An Bord Pleanála Reference: Case reference: JA18.314501  
314501: Properties at 7- 13 Dublin Street, lands to the rear of 1-9 The Diamond and 1-26 Dublin Street, the Courthouse car park, Lower Courthouse car park, Castle Road, and N54 Macartan (Broad) Road, townlands of Roosky and Tirkeenan, Co. Monaghan

Eddie O’Gara - 3 Tirkeenan, Monaghan, H18 YD72  
&  
on behalf of Love Monaghan Save Dublin Street

Issued Oct 2022

Submission: Eddie O'Gara CMLI MILI

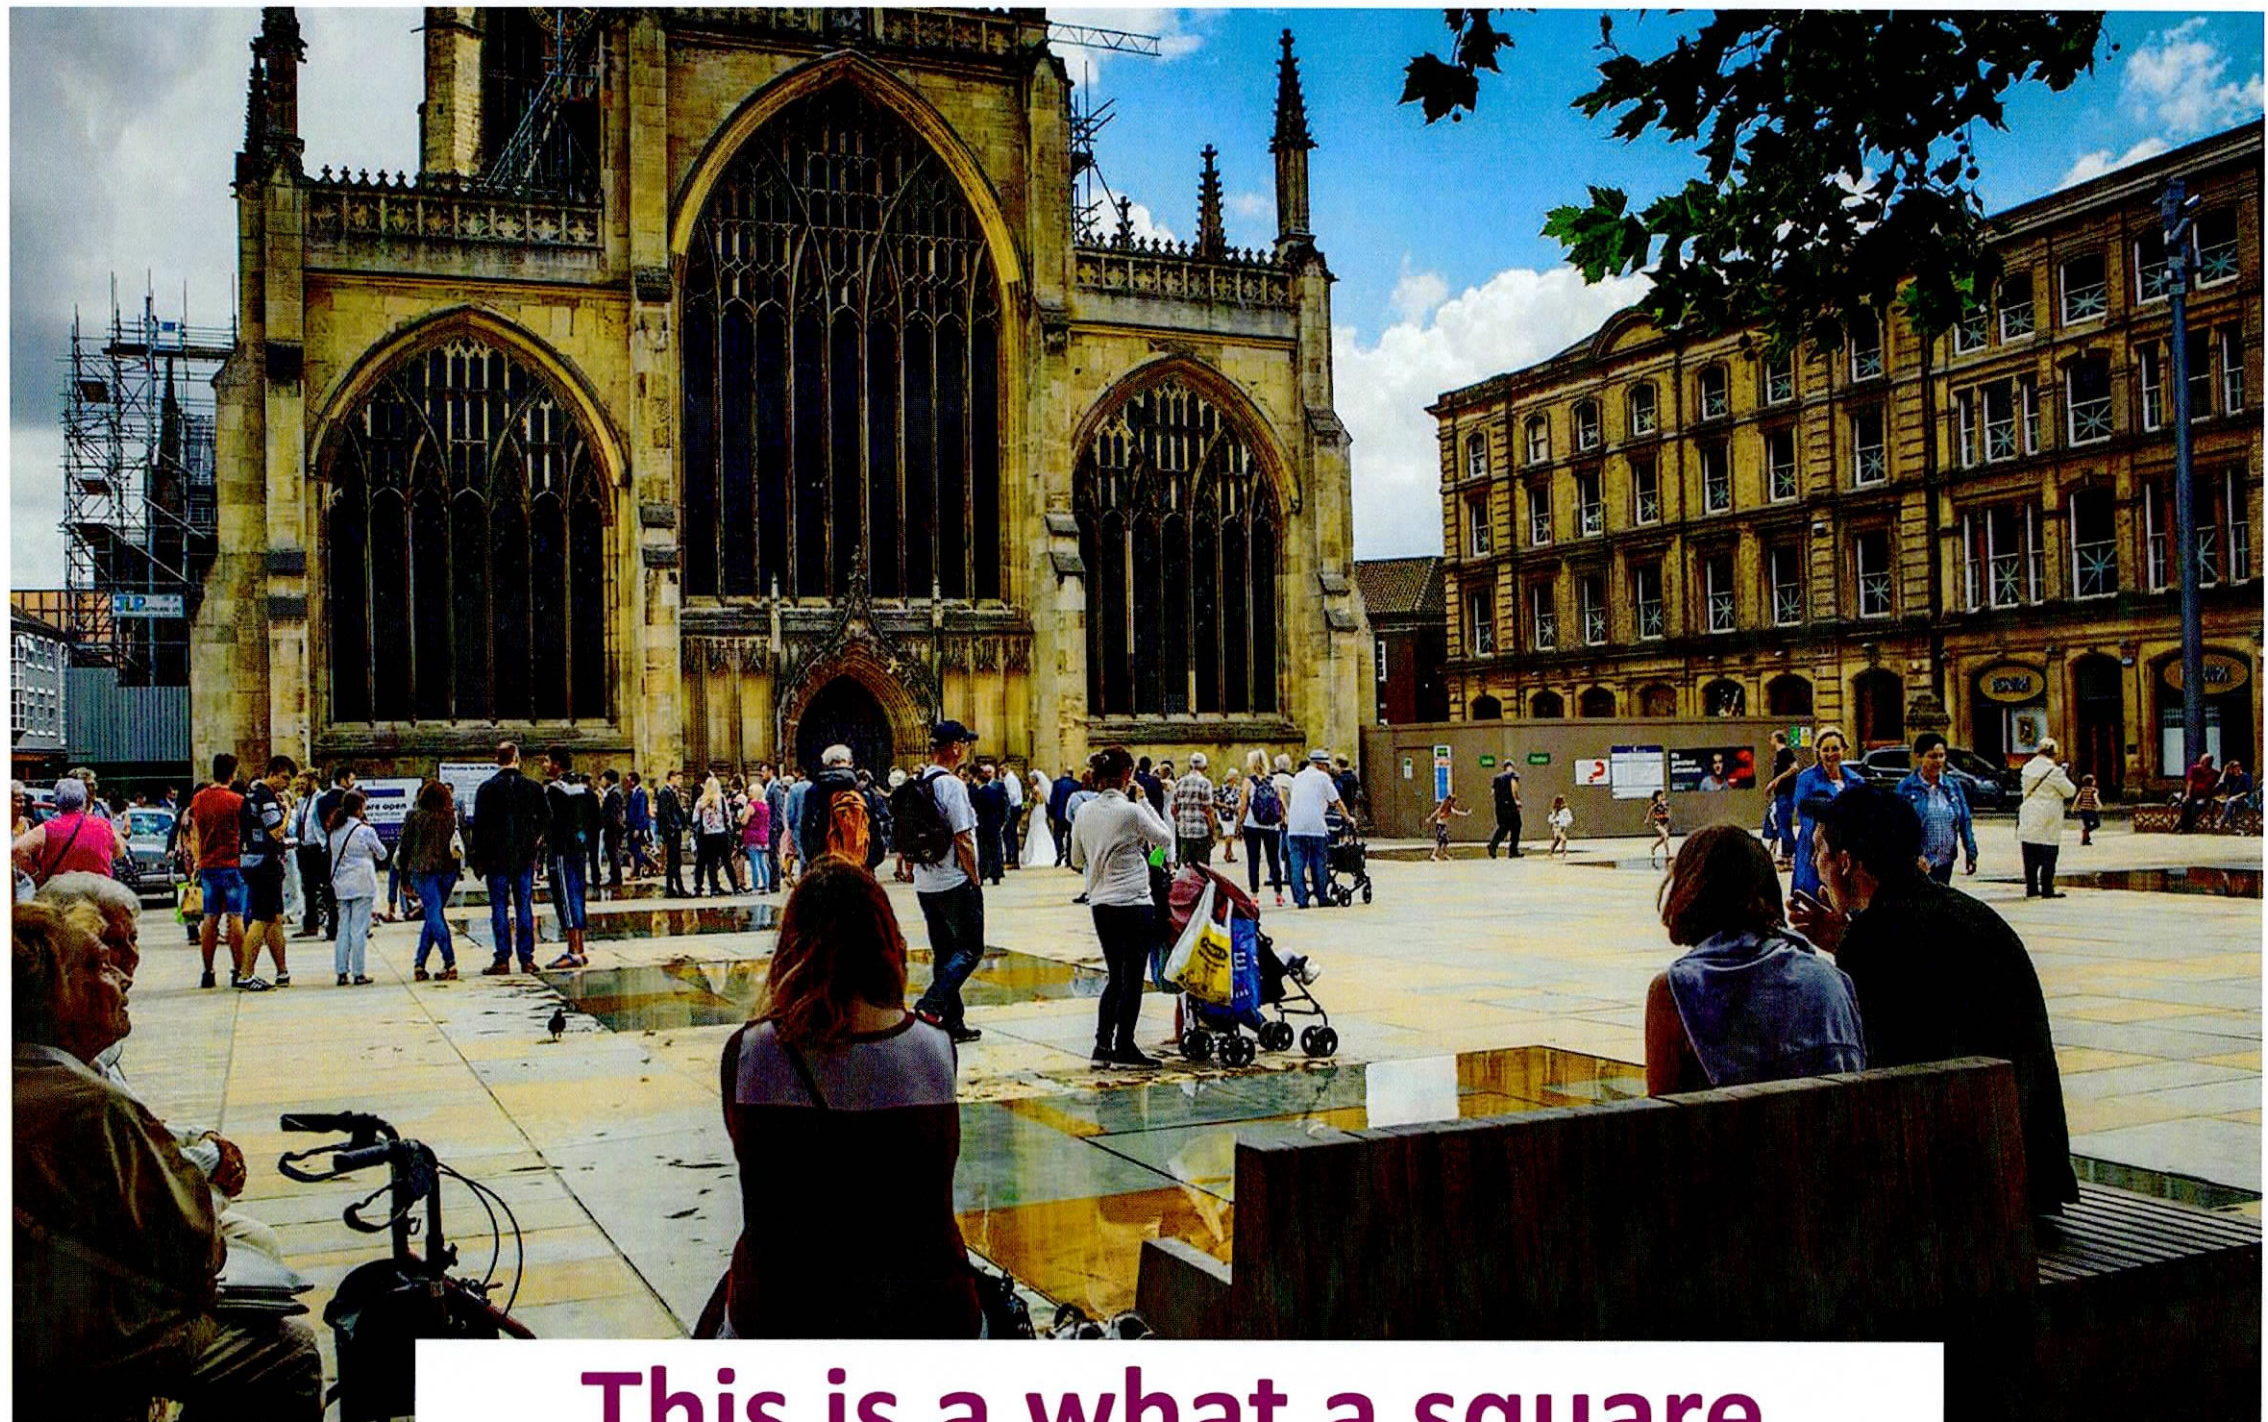
The Sheridan Woods Artist impression hides the reality that this is not a square but a car park.  
The RPS plans confirm the reality.

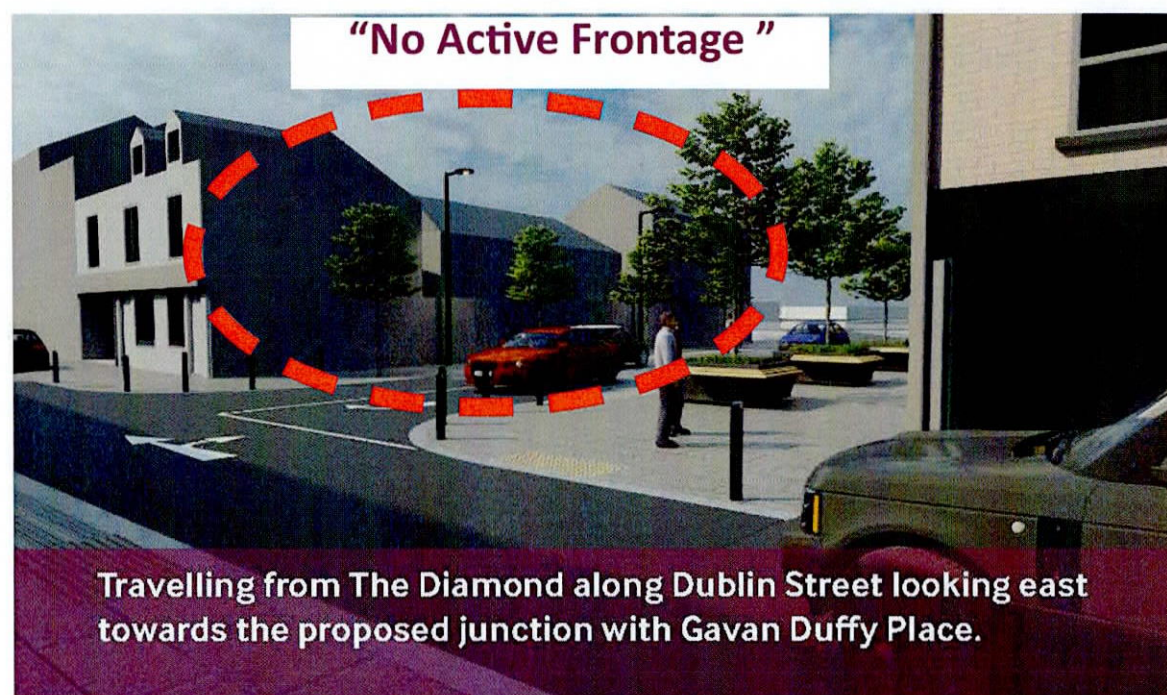
The Sheridan Woods Artist impression hides the reality that this is not place but actually a road. A road without any animation from the building edge and Car Parking!

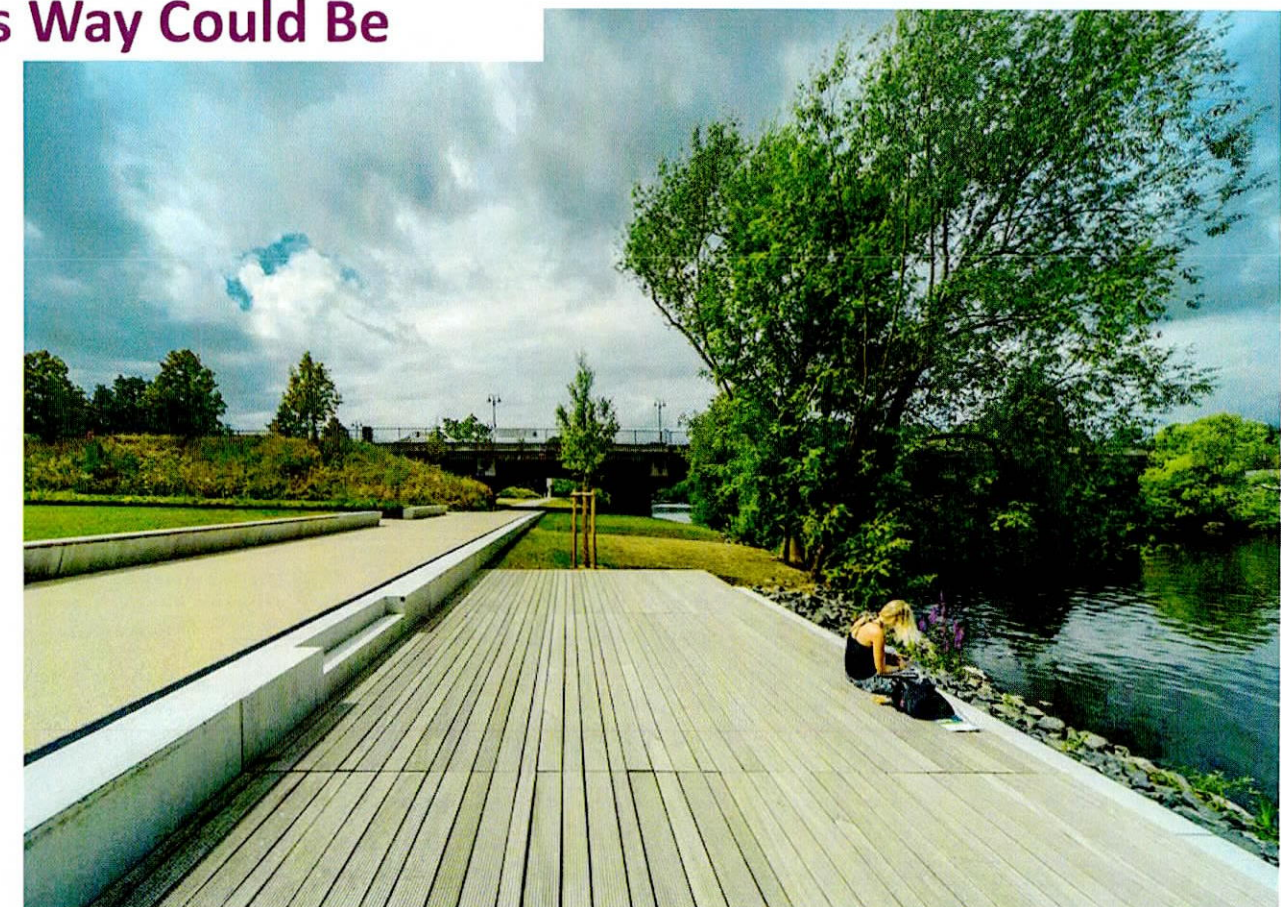
**This is a car park with some trees. A missed opportunity.**

Like other areas of the masterplan we have managed to turn our back on our prime opportunity areas in favor for the private car.

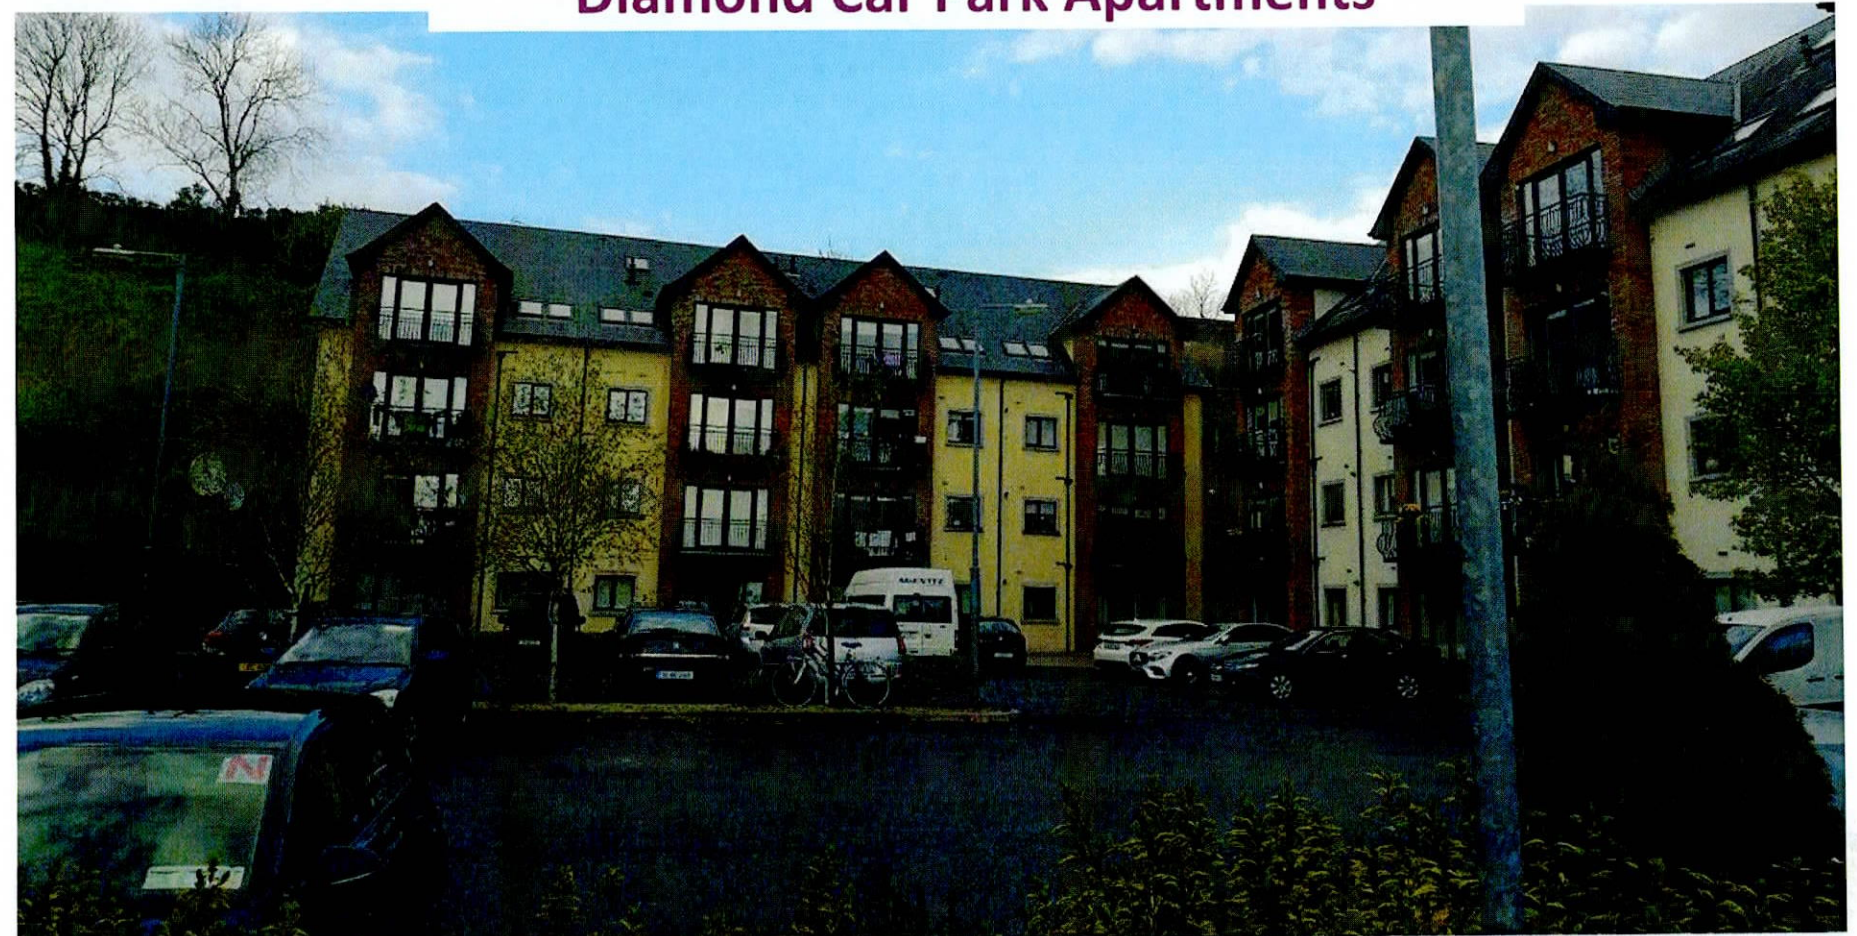
**The proposals could result in 4 buildings demolished on Dublin Street to create a road which views onto something potentially as soulless as this?**

**Without knowing the functions of the buildings and the needs of those users, the removal of buildings on Dublin Street is unnecessary.**

## The Wrapping Up - Additional Points of Note

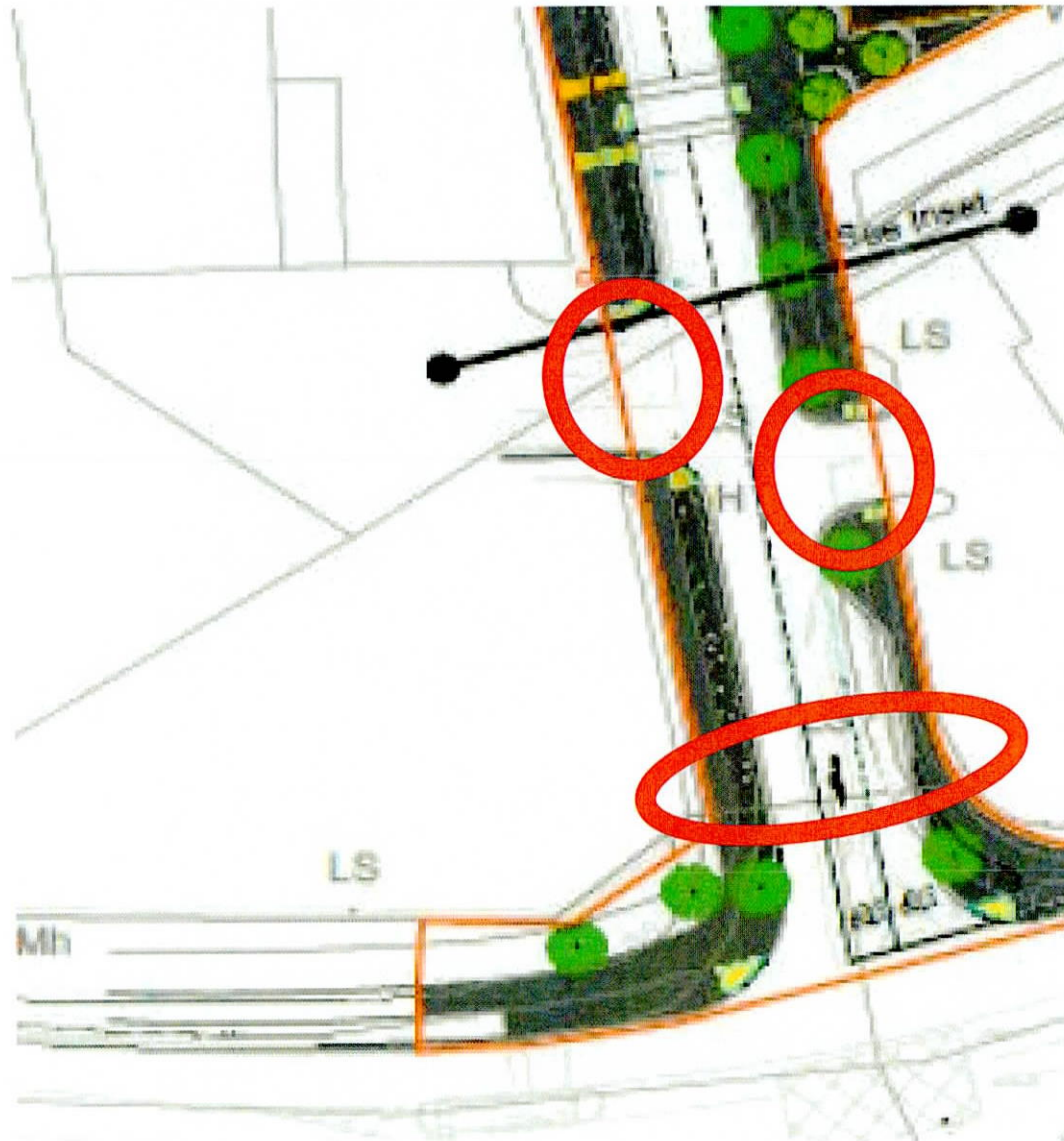
The proposed cycleway results in the removal of green infrastructure. Allocation for a cycle way should come from the carriageway or traffic calmed to make vehicles a guest in this location.

**Pedestrian circulation needs to be considered in the context of the entire movement in this location and not just from the car park to the shopping centre. Although not popular, the dedicated left turn should be removed and a raised pedestrian crossing added.**

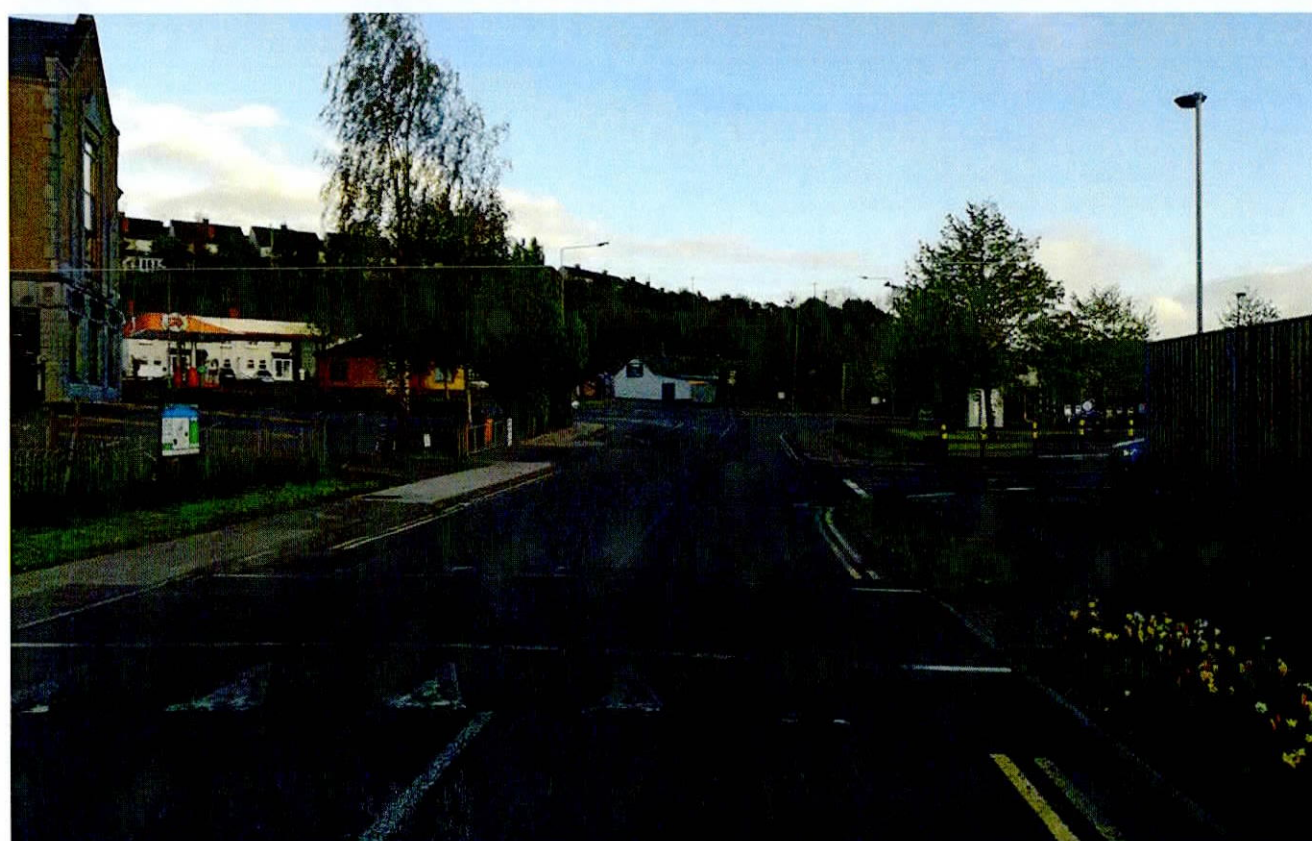
**The development of the backlands keeps car parking and vehicle movement the dominate feature of someone approaching Monaghan by road.**

**No active kerbside frontage, only car park, blank facade, service yard. This does not create an inviting and desirable entrance to the town.**
